DECISION No 30/2020
OF THE EUROPEAN UNION AGENCY
FOR THE COOPERATION OF ENERGY REGULATORS
of 30 November 2020

**ON THE CORE CCR TSO's PROPOSAL FOR THE METHODOLOGY FOR
COST SHARING OF REDISPATCHING AND COUNTERTRADING**

Figure 1: The difference between two considered options for priorities of flows

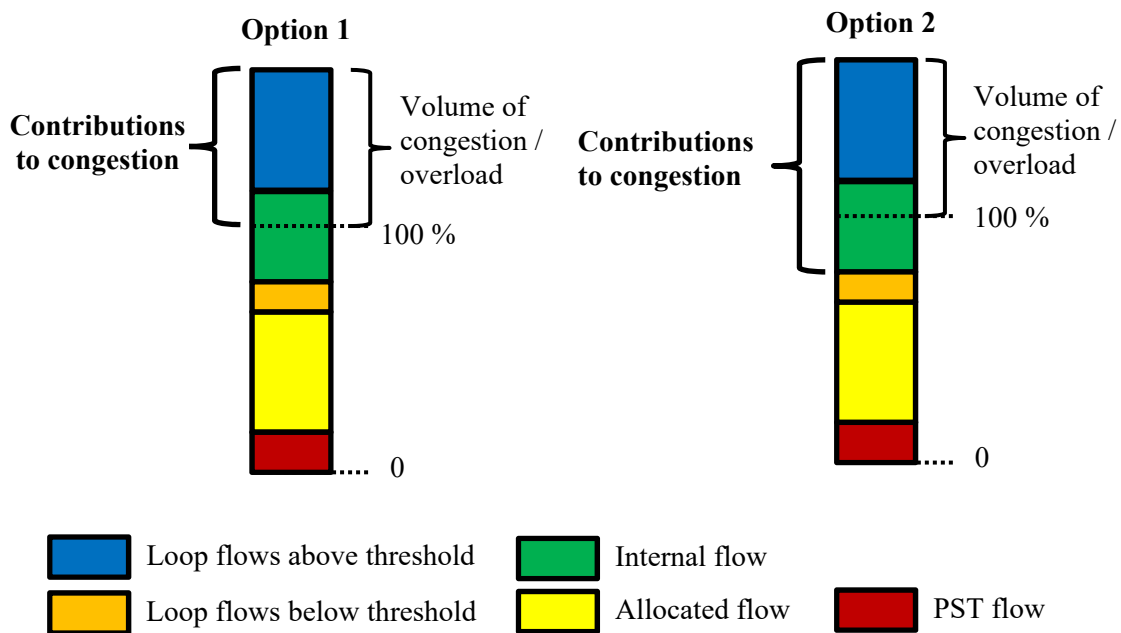
- (128) Option 1 and 2 are presented in the figure below, which shows the stacking of different flow components in relation to the maximum capacity of the network element (denoted with 100%). In Option 1 of this example all loop flows are identified as contributors to congestion, whereas only the internal flow which is needed to cover the remaining congestion is identified as contributor to congestion. In Option 2, all loop flows and the whole internal flow are identified as contributors to congestion, however, since their sum is larger than the volume of congestion they are scaled down afterwards to become equal to the volume of congestion (i.e. volume of overload). This scaling does not change the relative shares of loop flows and the internal flow.

- (129) ACER carefully evaluated different arguments from Core TSOs and regulatory authorities, analysed possible options and performed the simulations of investigated options based on the data used in the Experimentation report. While ACER recognises some validity of arguments of both groups of Core TSOs and regulatory authorities, it considers that the arguments of the majority of TSOs and regulatory authorities are stronger in this specific case.
